Docket Number:	17-AAER-06
Project Title:	Commercial and Industrial Fans & Blowers
TN #:	224835
Document Title:	Henry E. Ernst Comments Response to California's proposed appliance efficiency regulations for CIFBs
Description:	N/A
Filer:	System
Organization:	Henry E. Ernst
Submitter Role:	Public
Submission Date:	10/1/2018 7:54:49 AM
Docketed Date:	10/1/2018

**Response to California's proposed appliance efficiency regulations for
CIFBs**

Daikin Applied Comments: Commercial and Industrial Fans and Blowers (CIFB)

Subject: Docket # 17 AAER-06

Redesign Cost

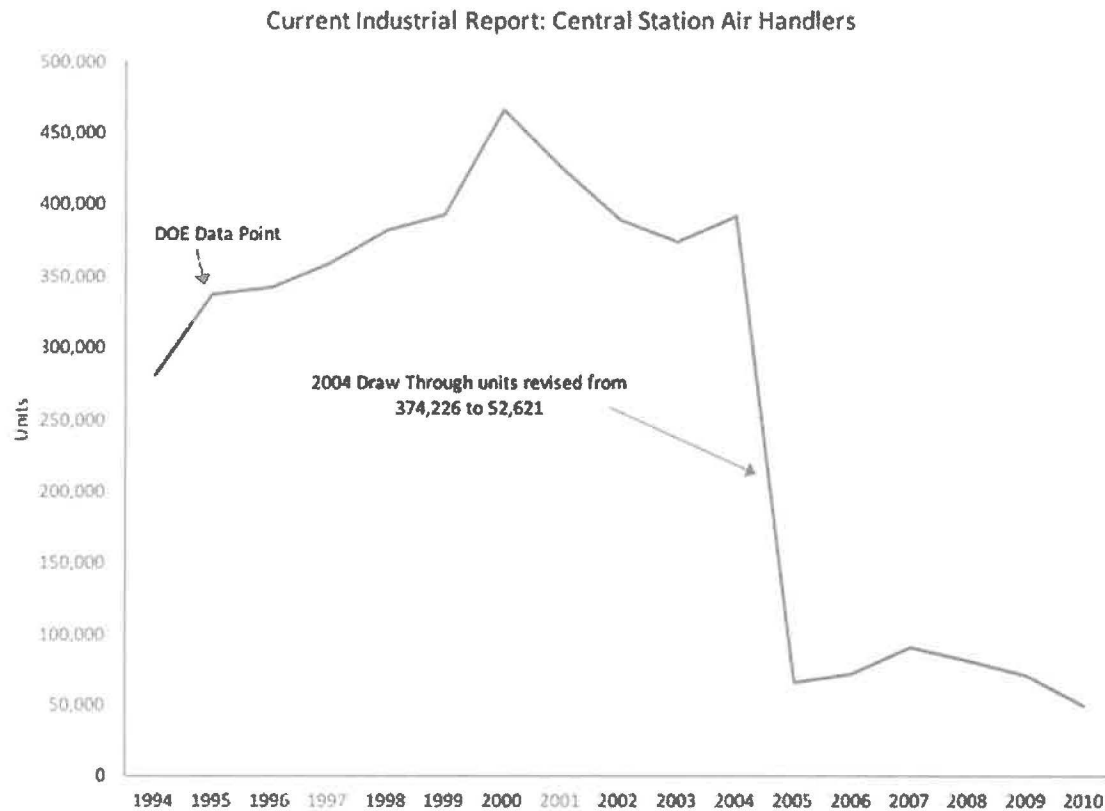
We request California consider the potential consumer impact [Staff Report Table A12] if DOE estimated conversion costs [blue shading] are passed on to customers as extra cost [orange shading.] Corrected consumer benefit ratios are unfavorable as shown in bold font. Note that DOE estimated, extra cost and redesign conversion costs are vastly understated as explained in separate comments.

Table A12 Corrected To Include DOE Redesign Cost 2 x average size

Panel	\$ 147	\$ 8.66	21	\$ 182	\$ 106	0.72
Housed	\$ 1,498	\$ 64.52	18	\$ 1,161	\$ 709	0.47
Unhoused	\$ 355	\$ 22.03	17	\$ 375	\$ 243	0.68
